City of Alexandria, Virginia

MEMORANDUM

SUBJECT: CONCEPT REVIEW OF 1201 EAST ABINGDON DRIVE
BAR CASE # 2023-00245

BAR CONCEPT REVIEW PACKAGE

Figure 7: Enlarged elevation of addition showing offset brick piers at glazing bays

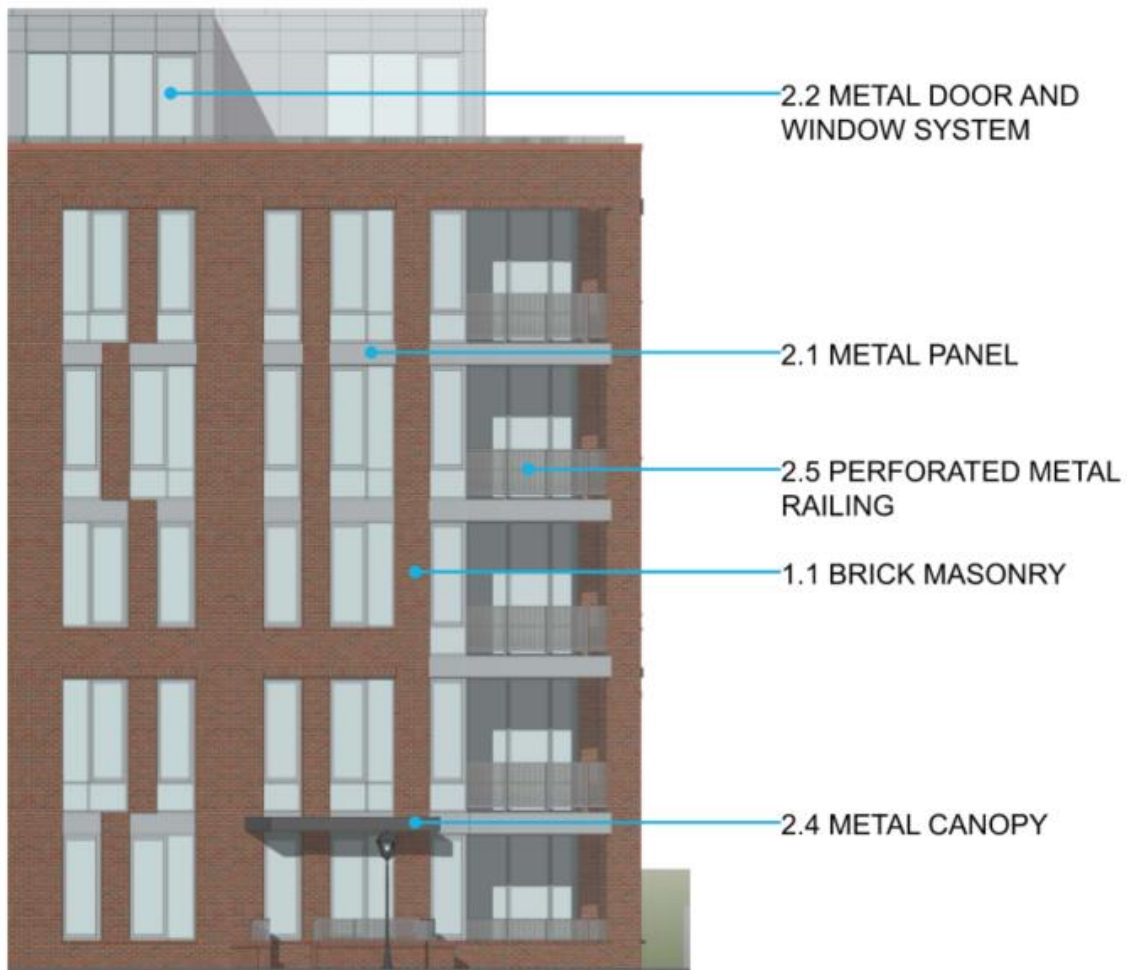
Brick Piers at Addition Window Bay

The windows on the proposed addition are ganged together into a two-story grouping at the ground floor and a three story grouping for the upper levels. This grouping effectively creates a base for the building and allows the building to become visually lighter as it gets taller. Each of these bays features a brick vertical divider that is offset from floor to floor (Figure 7). Staff finds this design to be unique and to successfully add visual interest to a simple overall design. The offset of the vertical brick elements places the middle sections such that the brick is above a horizontal metal panel. Staff finds this to be an awkward relationship with the visually heavy brick sitting on top of the light metal panels. Staff encourages the applicant to retain this offset composition but to explore alternate materials for the vertical brick dividers. Allowing the vertical material to be different than the horizontal helps to make the overall composition more complex. One possible alternative would be to use some type of tile in this location in lieu of the brick. This would retain the modular quality of the brick and would be clearly different than the metal panels without the heaviness of the masonry material.

Figure 8: sketch showing proposed courtyard

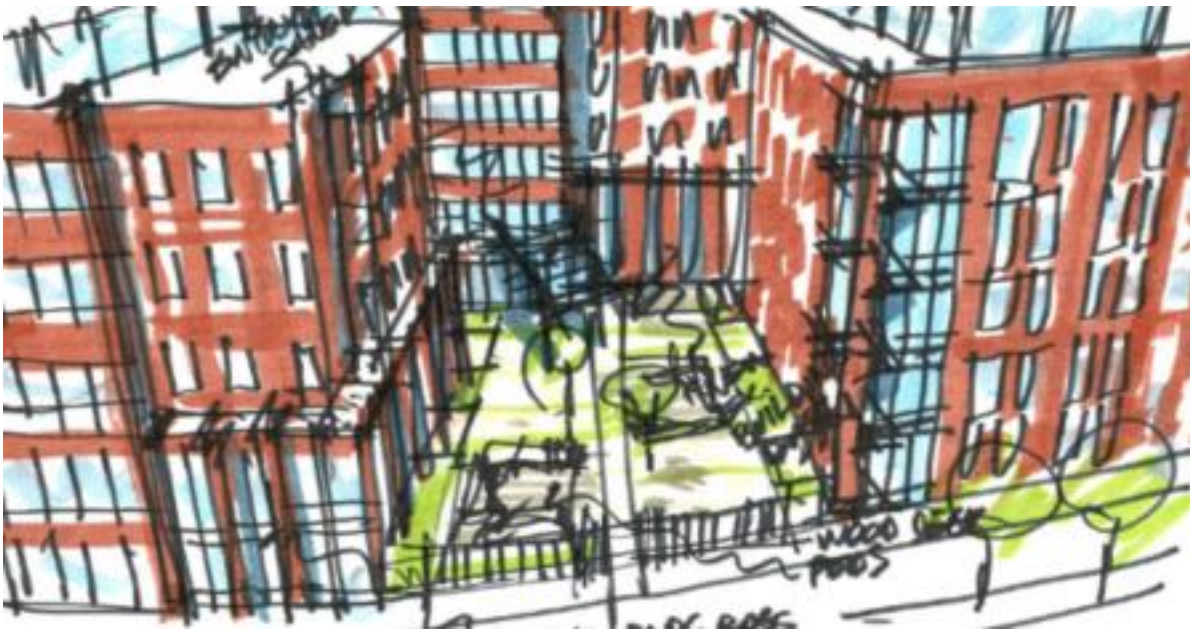
Courtyard and Main Entry Canopy

With the construction of the proposed addition at the south end of the project site, a new courtyard will be created facing Abingdon Drive and the Parkway beyond. The submitted documents do not show a lot of details regarding the design of this courtyard; renderings show ground floor unit entries, and a design sketch shows what appears to be a building entry canopy (Figure 8). Staff appreciates the conversion of the existing surface parking lot into a courtyard and encourages the applicant to carefully consider the design of the space and how it interacts with the public sidewalk. Based on the submitted plans, it appears that this courtyard will be the location of the main building entrance. Staff supports this approach of moving the entrance directly off of the narrow sidewalk and creating an entrance sequence in the courtyard. The design of the entry canopy will be critical to calling attention to the main entrance and staff encourages the applicant to design an element that will be immediately recognizable while compatible with the overall architecture.
